Re: New York Methodist Hospital
Center for Community Health
505-525 6th Street (Block 1084,
Lots 25, 26, 28, 39-44, 46, 48,
50-59, 164, 1001, and 1002)
BSA Cal. No. 289-13-BZ

We are submitting this letter in connection with the application by New York Methodist Hospital ("NYM" or the "Hospital") for a variance to facilitate the development of a new ambulatory care facility (the "Center") Hospital's main campus in Brooklyn. This letter and the attached materials provide responses to questions asked by the Board at the February 11, 2014, public hearing on the application, as set forth below.

LESSER VARIANCE REDUCTIONS

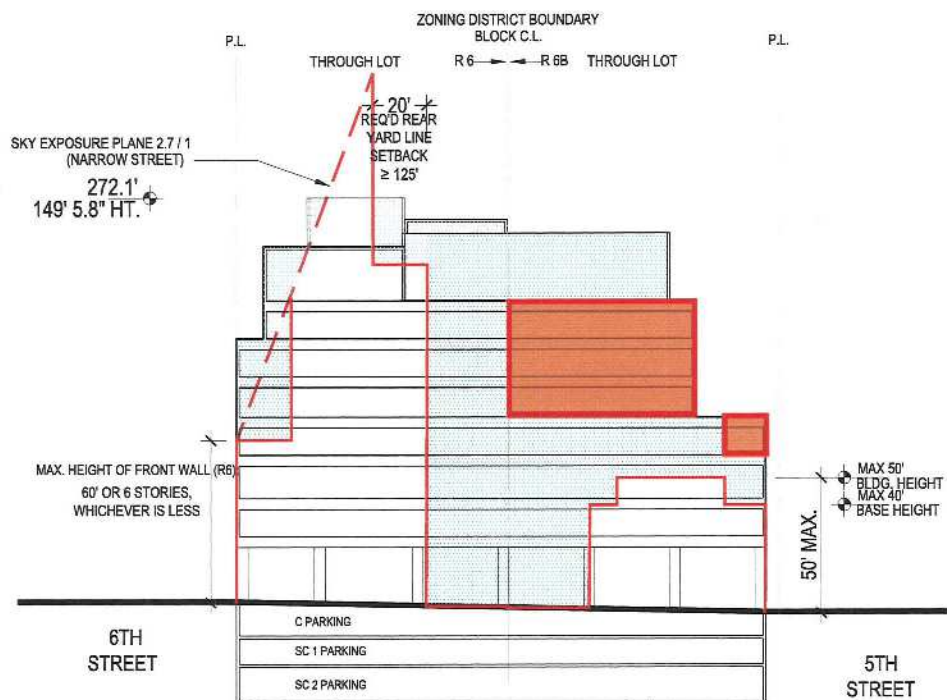
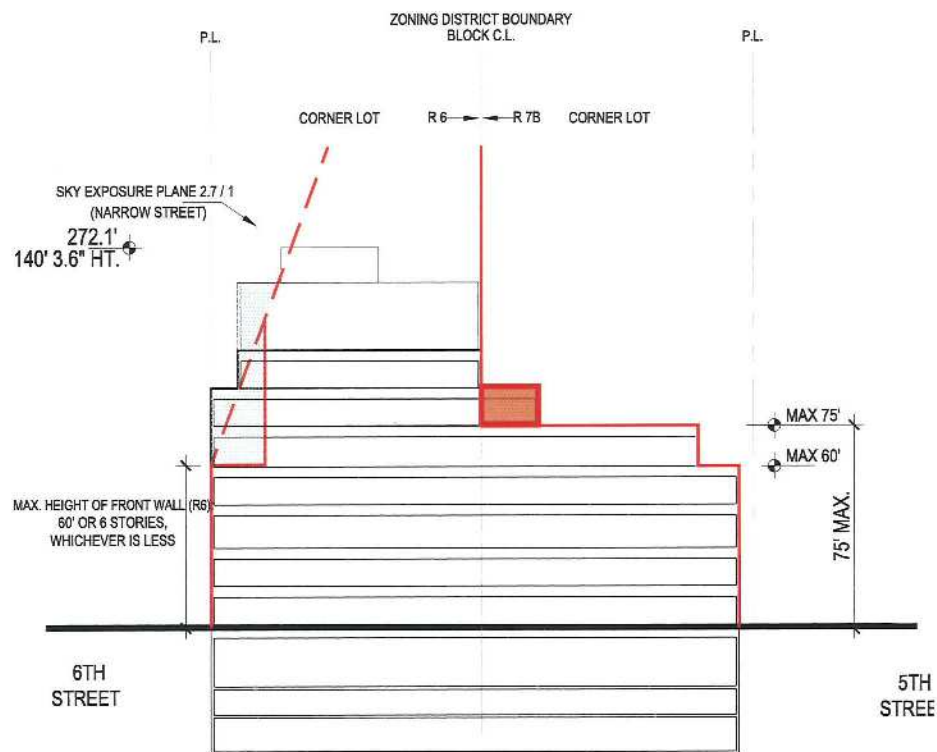
1. *Provide studies for lesser variance options for the Center that (i) fully comply with the applicable height and setback regulations in the R7B district and (ii) reduce the degree of the building's non-compliance with the applicable height and setback regulations in the R6B district.*

The Lesser Variance Study examines three modifications to the proposed Center's building envelope: (i) an increased setback at the 4th floor in the R6B district; (ii) an increased setback at the 5th through 7th floors in the R6B district; and (iii) an increased setback at the 6th floor in the R7B district to achieve full compliance with the R7B height and setback regulations. The portions of the building, as currently proposed, that would be eliminated by such modifications are shown on the Lesser Variance Reductions diagrams attached to this letter.

NY Methodist Hospital, Brooklyn
Ground Floor Plan

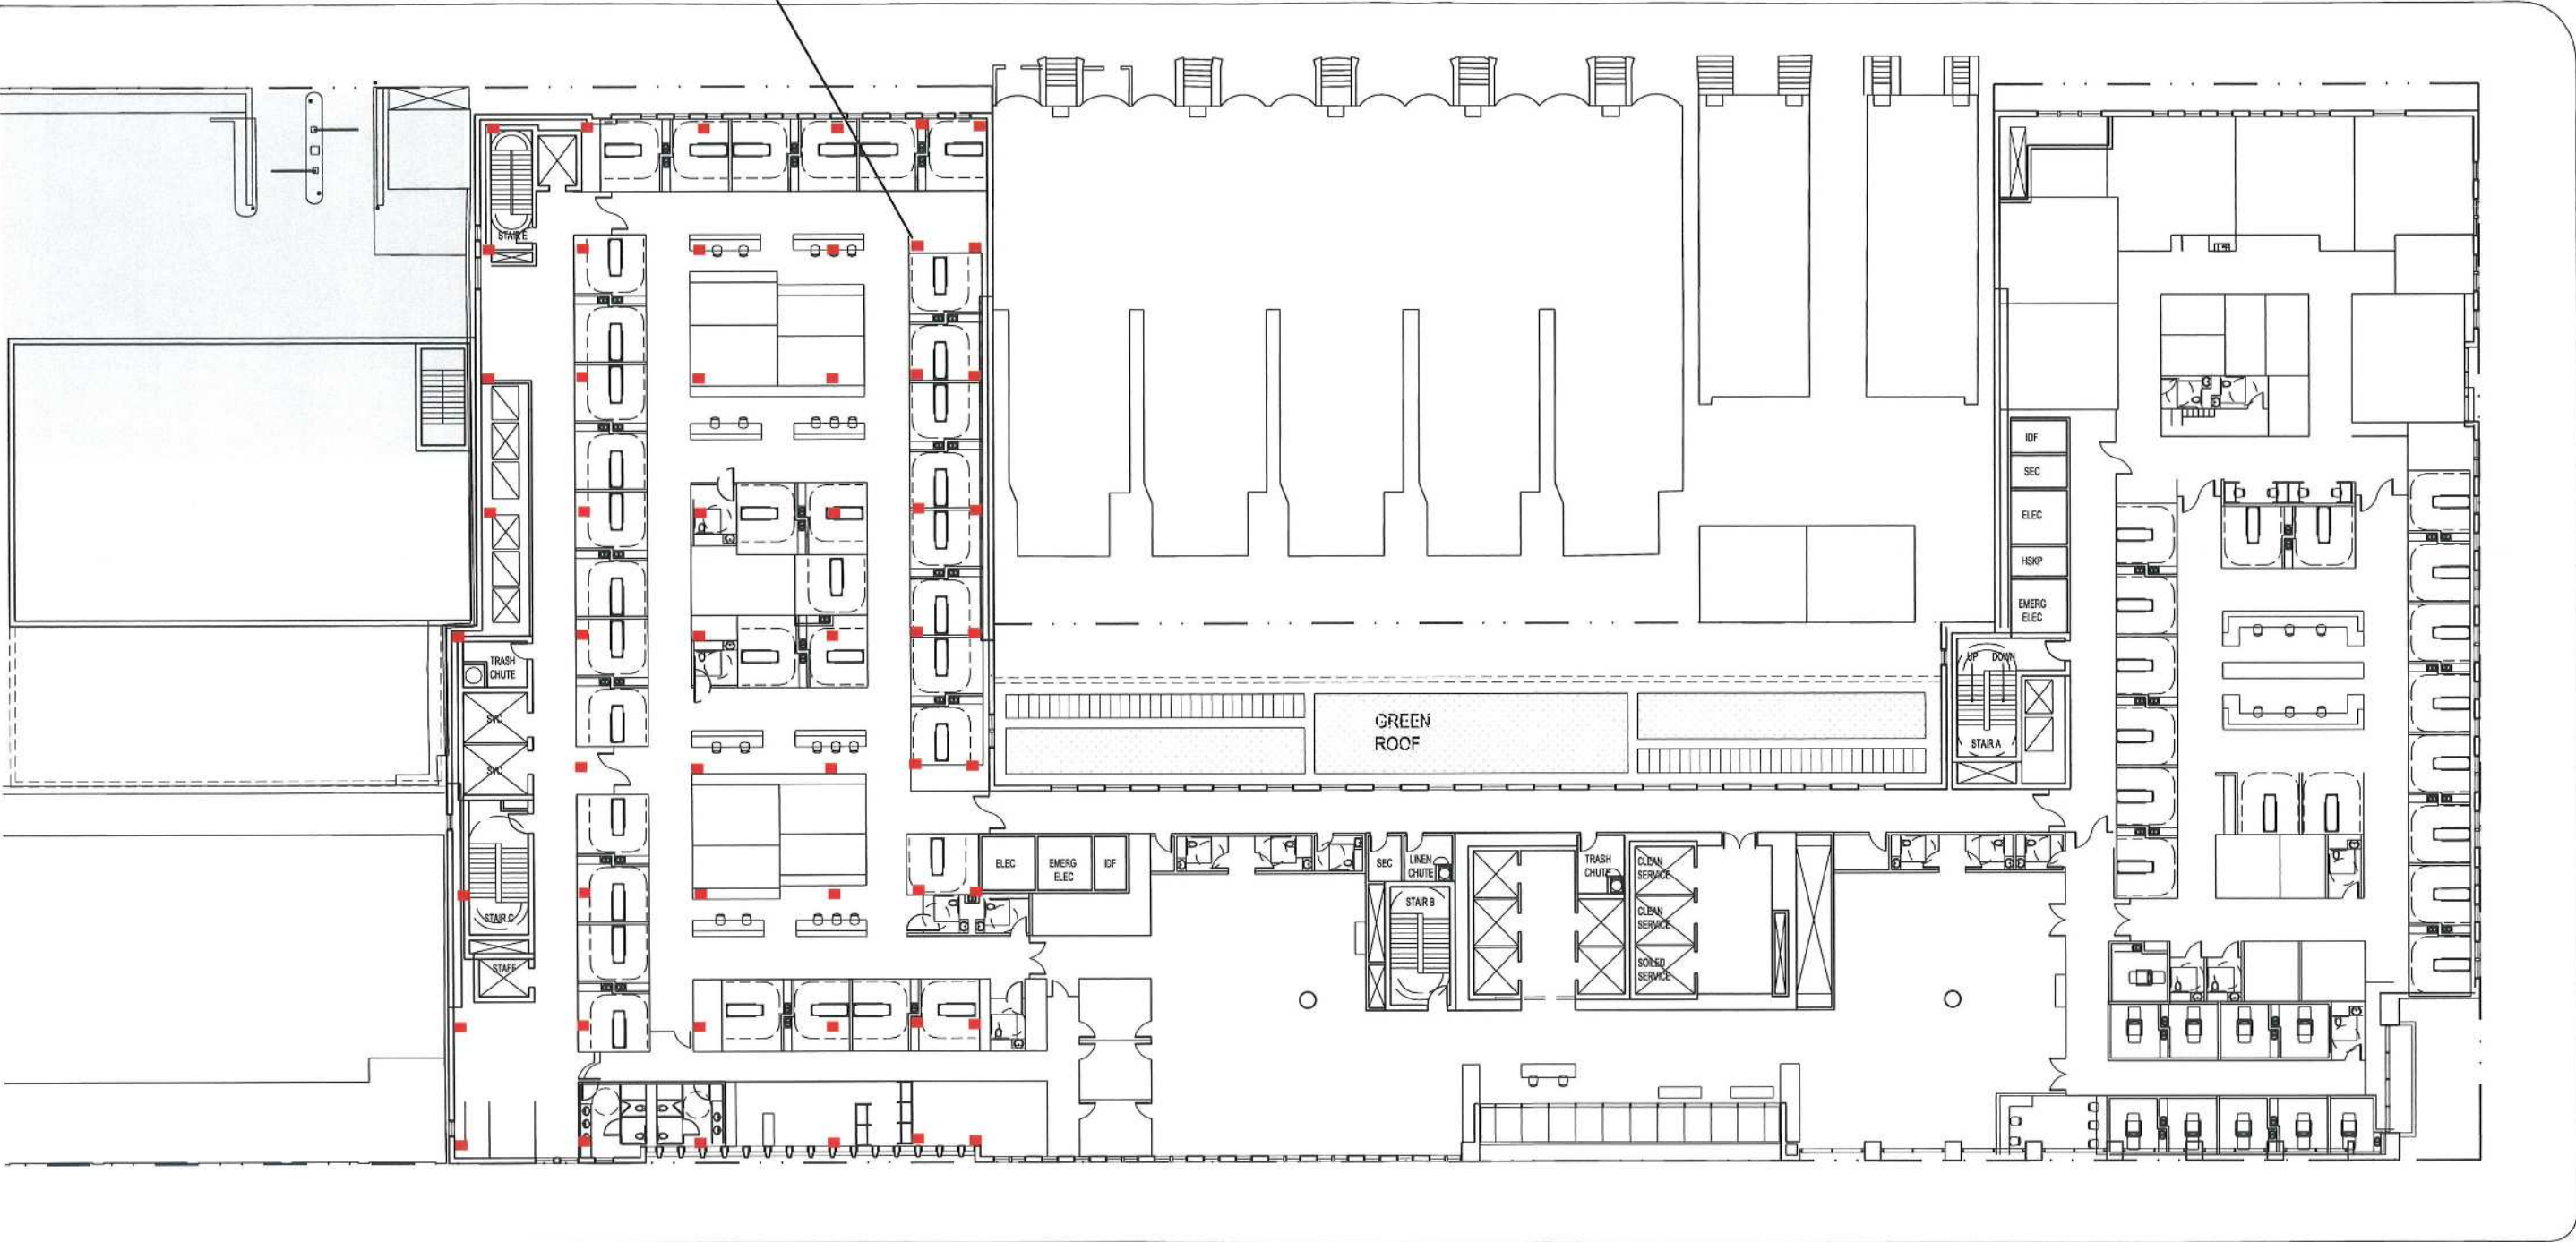
- To accommodate the surgical suite, the current design for the Center has a stiffer floor construction at the 3rd floor to reduce vibration and deflection. This stiffer construction is achieved by utilizing standard-depth beams over shorter spans, requiring a denser column spacing on the floor immediately below. The more tightly-spaced columns do not significantly impede the configuration of CSS and Materials Management, but they would result in compromised or displaced PACU units if the PACU suite is relocated to the 2nd floor. (See Lesser Variance Study, 2nd Floor Plan Diagram)

Compromised / Displaced
PACU due to denser column
grid for Surgical Suite above

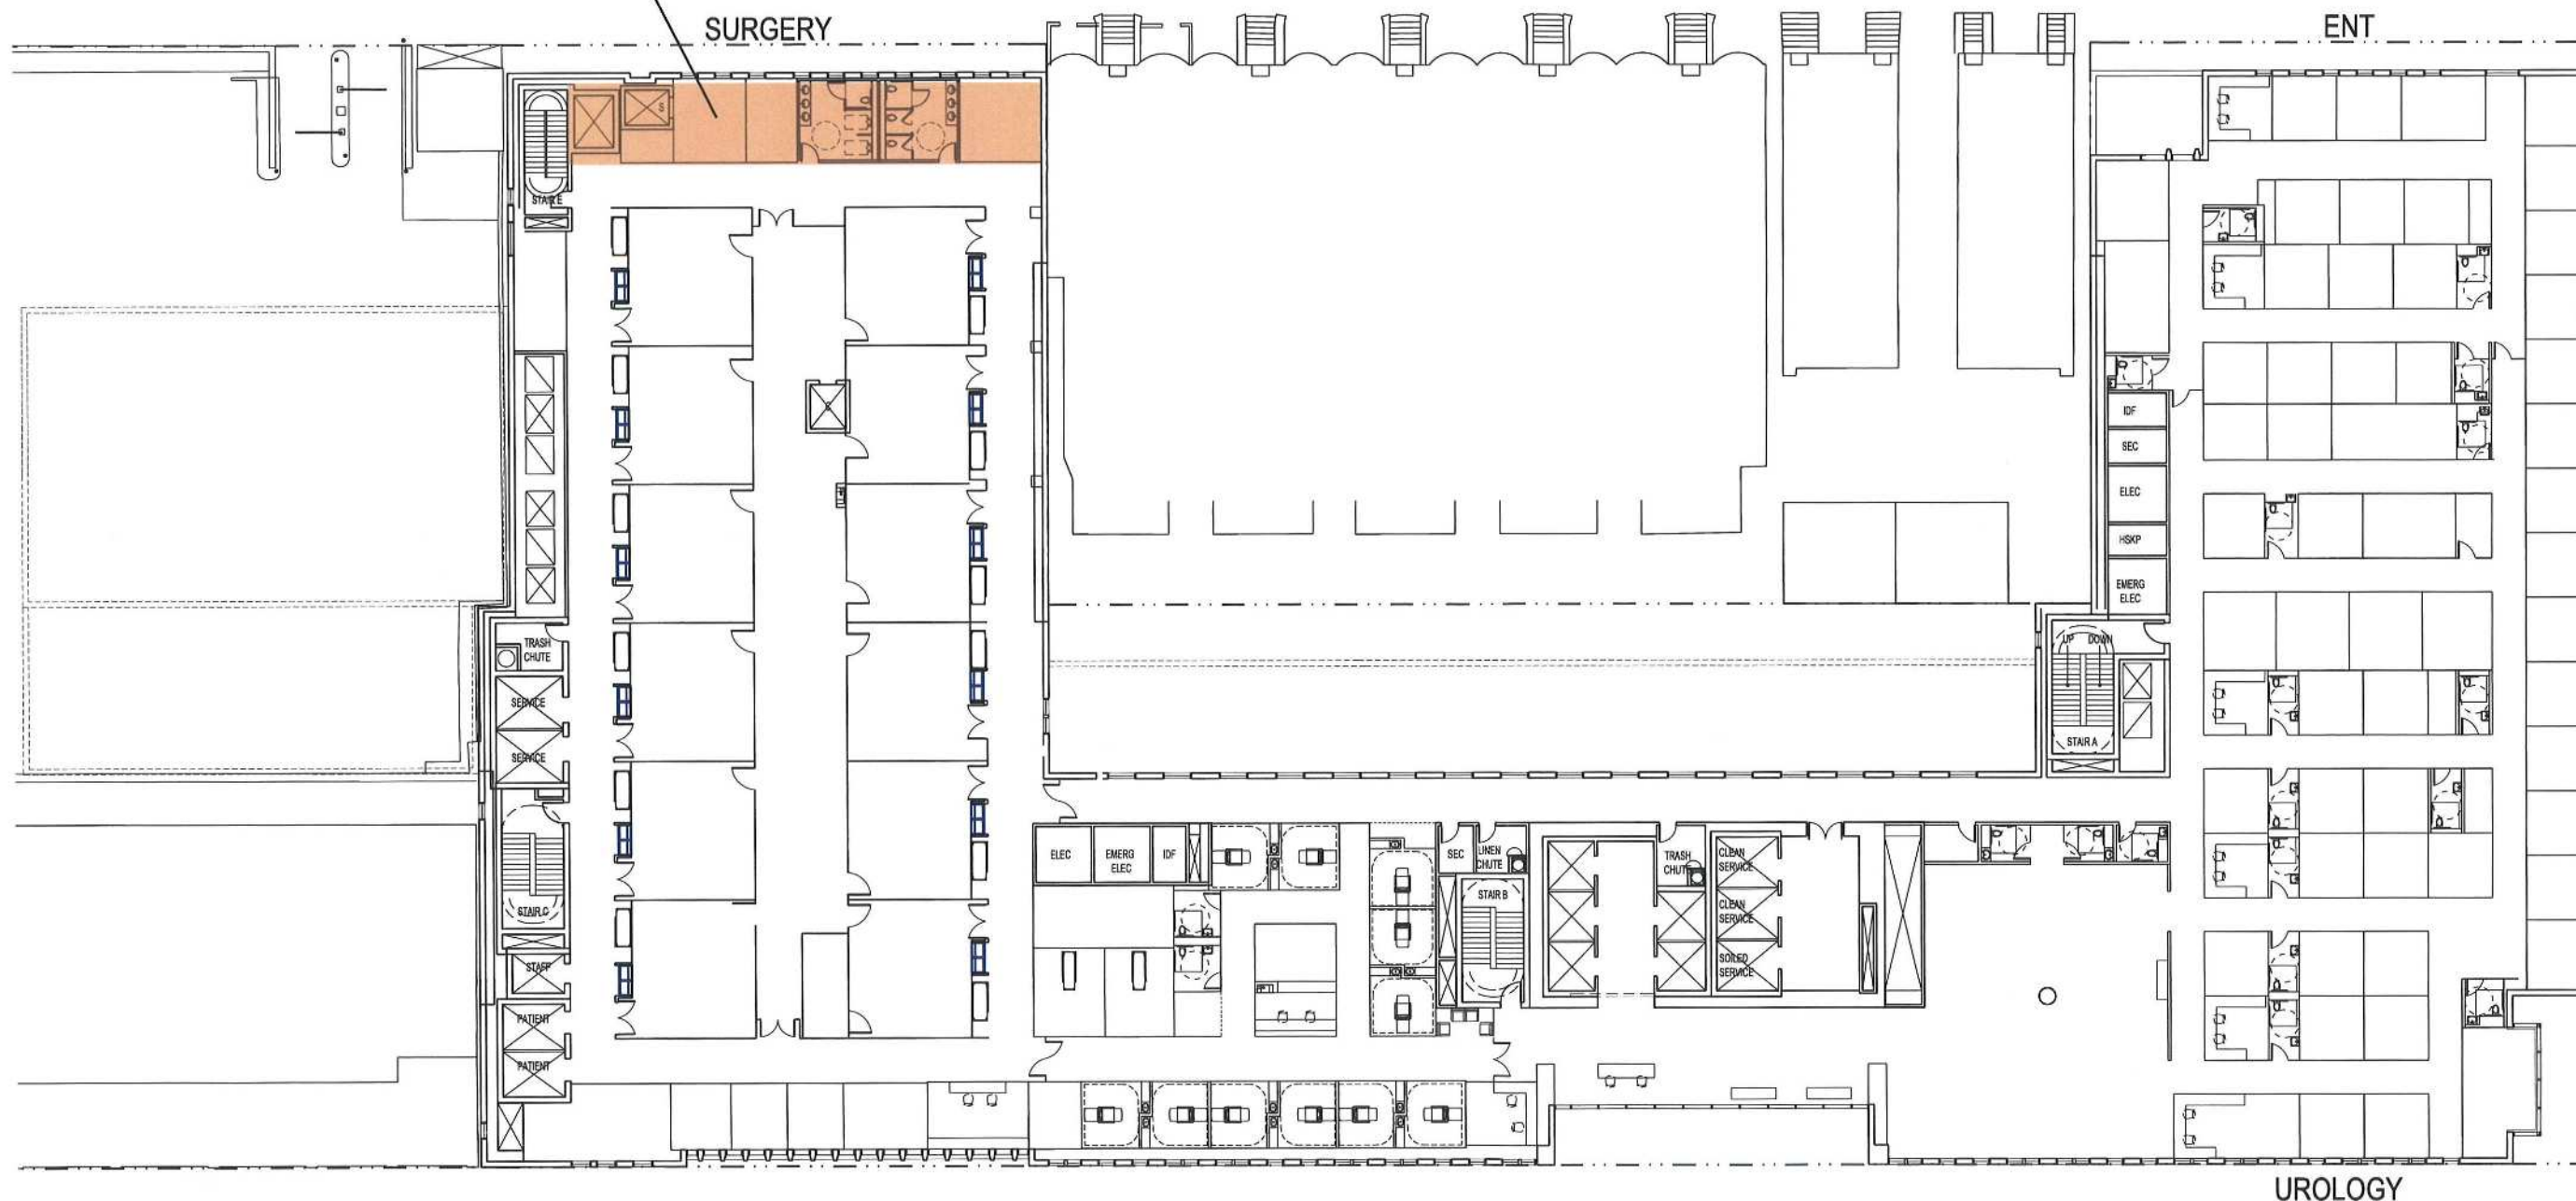
- The relocation of CSS and Materials Management to a floor with smaller dimensions requires a reduction of the program area for one or both of these functions, with impacts on the efficiency of the building's operations. (See Lesser Variance Study, 4th Floor Plan Diagram)

- The location of CSS on the 4th floor with an increased setback from 5th Street would require that the building's soiled elevator and flanking support spaces be moved southward to remain within the building envelope. (See Lesser Variance Study, 4th Floor Plan Diagram) In order to accommodate the relocation of the elevator shaft and support spaces on the 3rd floor while maintaining sterile connections, the building's surgical suite must be reduced in size. This would require the displacement of support space or a reduction in the size of one or more ORs, with a resulting reduction in services to the community. (See Lesser Variance Study, 3rd Floor Plan Diagram)

require additional travel times for each delivery made to these spaces. (See Lesser Variance Study, 4th Floor Plan Diagram)

PACU and Special Procedures relocated from Fourth Floor
